From: Topher Mathers
Sent: Saturday, July 09, 2022 10:42 PM
To: PublicComment-AutoResponse
Cc: Gordo, Victor; Hampton, Tyron; Williams, Felicia; Kennedy, John J.; Masuda, Gene; Rivas, Jessica; Madison, Steve; Wilson, Andy
Subject: Agenda Item #21 - South Fair Oaks Specific Plan

Re: South Fair Oaks Specific Plan Update

RE: South Fair Oaks Specific Plan

Maintaining 20' Metro Safety Setback

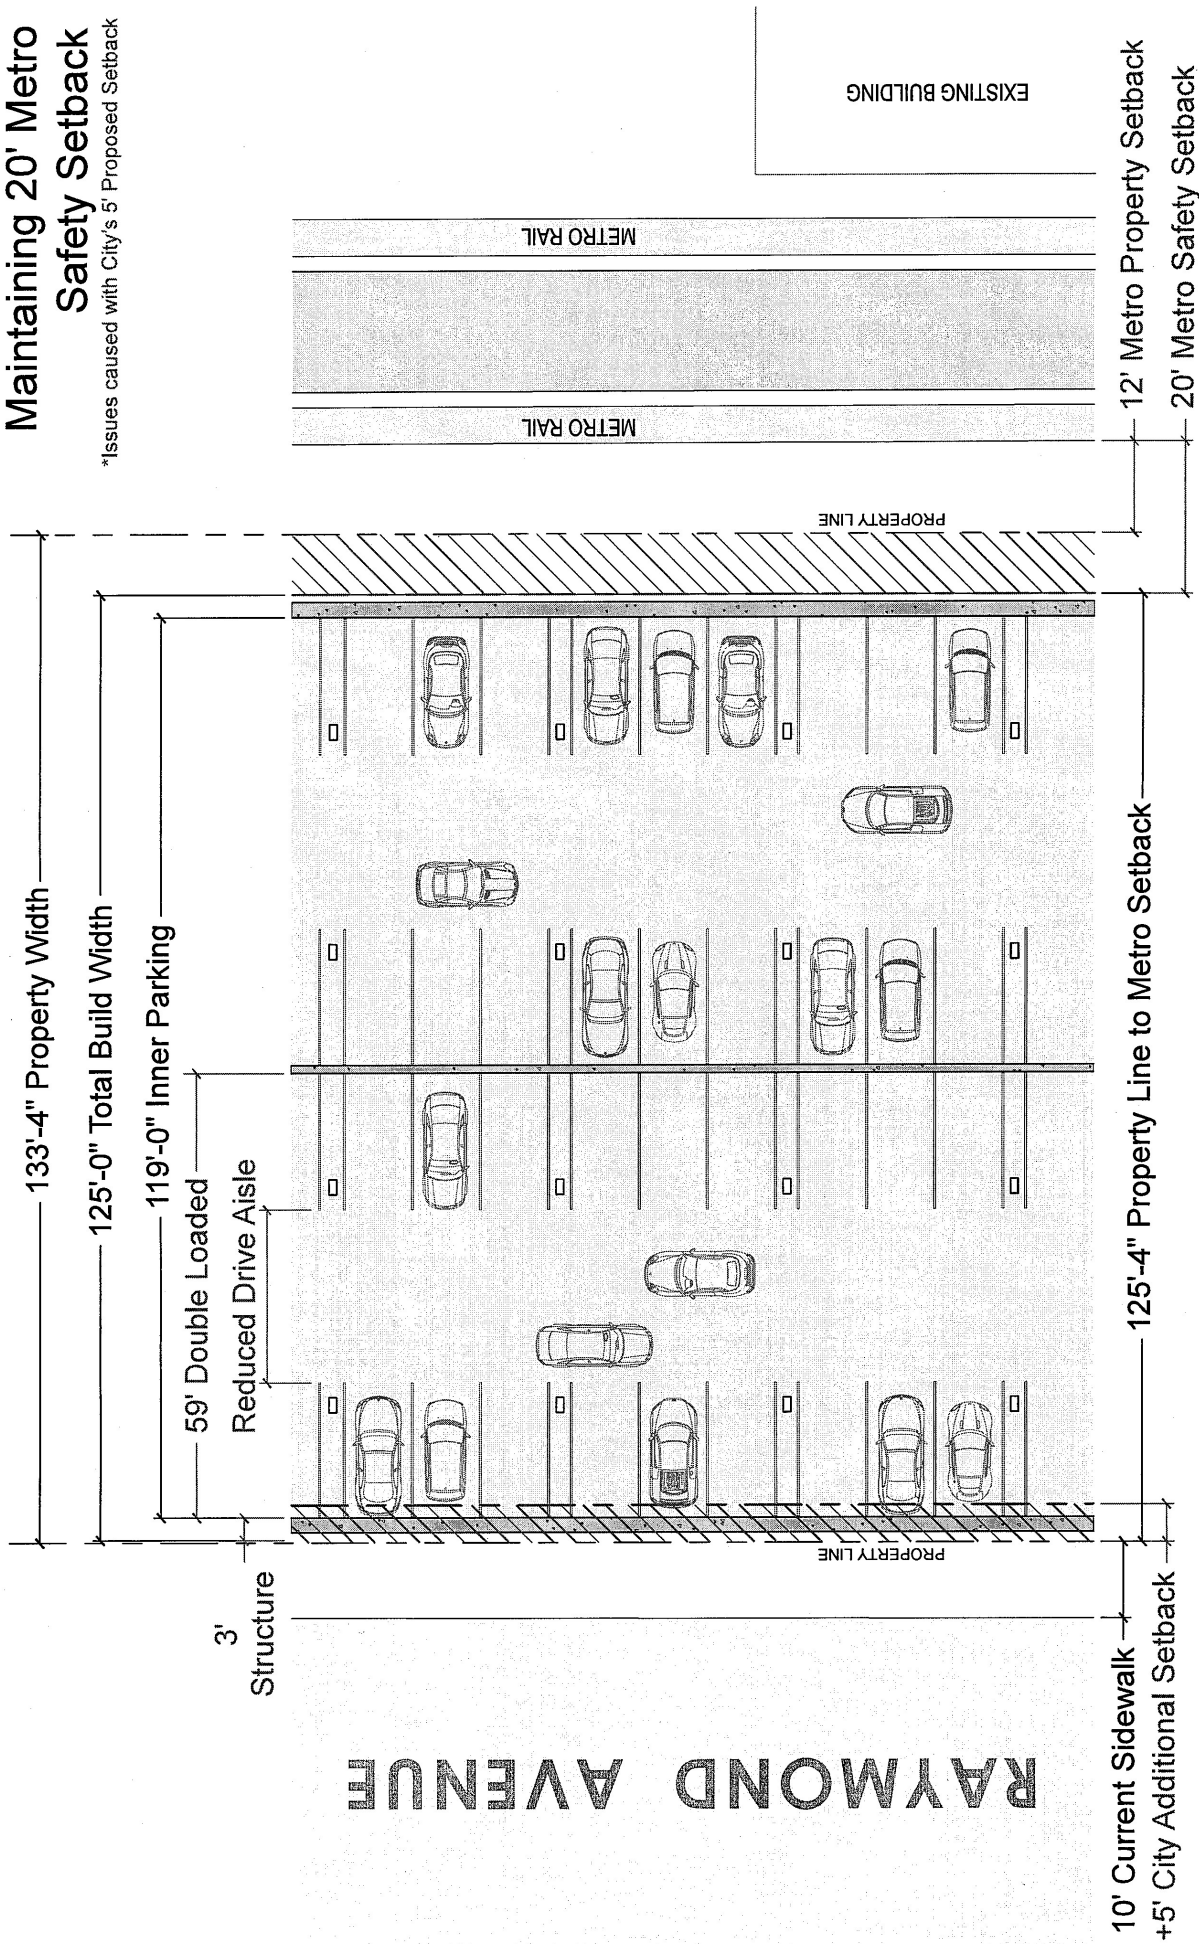
1. Subterranean Setbacks would prevent normal garages being built near the metro station – resulting in significant hardships, deeper and/or taller buildings, and large community and environmental impact.

Issue: In April 2022 at the last minute, a new 5' subterranean setback was added to the SFOSP draft. The proposed setback would impact the ability to build a subterranean garage near the Fillmore Station where property widths are already at a bare minimum. Please see the attached diagram elaborating on the problem.

Properties on Raymond by the Metro station were previously narrowed and are now at a minimum for efficient subterranean parking design (before this new additional setback): Properties on the east side of S. Raymond facing the Metro line were narrowed for the Gold line expansion. Further narrowing occurred near the Fillmore Station as wide station passenger platforms were placed between the tracks. This widening at the Metro station leaves just enough width to accommodate a subterranean garage on west adjoining parcels.

New Metro Demands: When the Gold line was created, setbacks from the track were set at 10-12'. Recently Metro has set new guidelines and been demanding new development projects be offset 20' from Metro powerlines and related structure (8-10' further back from existing property and easement lines).

Problem for Development Along Metro line: Adding the new proposed 5' subterranean setback to Metro's 20' track line setback would narrow the width of lots adjacent to the station to the point of preventing efficient subterranean garage level design. This 5' subterranean setback would demand narrower, deeper, inefficient garages (or taller buildings with above grade parking) that would deter development intended by the plan.

This proposed setback, with associated increased project depth (or possibly height), would significantly increase economic and environmental costs, increasing construction time, dump truck trips on our streets, impair guest/user experience, and significantly add to development time. The deeper excavation depth (near Metro tracks) would require difficult negotiation with the Metro bureaucracy likely prolonging the path to bringing development to this area. For other properties in the area, the proposed setback also remains a challenge out of proportion with its supposed benefits.

Proposed Solution: Please drop the proposed setback and let the planning process address and protect trees (as for Huntington Hospital's recent project). This could result in soil wells, setbacks around some trees (and only around trees) for other projects, and/or other solutions. The planning process would consider factors such as: (1) specific tree species and their needs, (2) adequacy of land around trees to serve their needs, (3) distance of trees to proposed construction, and (4) amount of private land in each direction required.
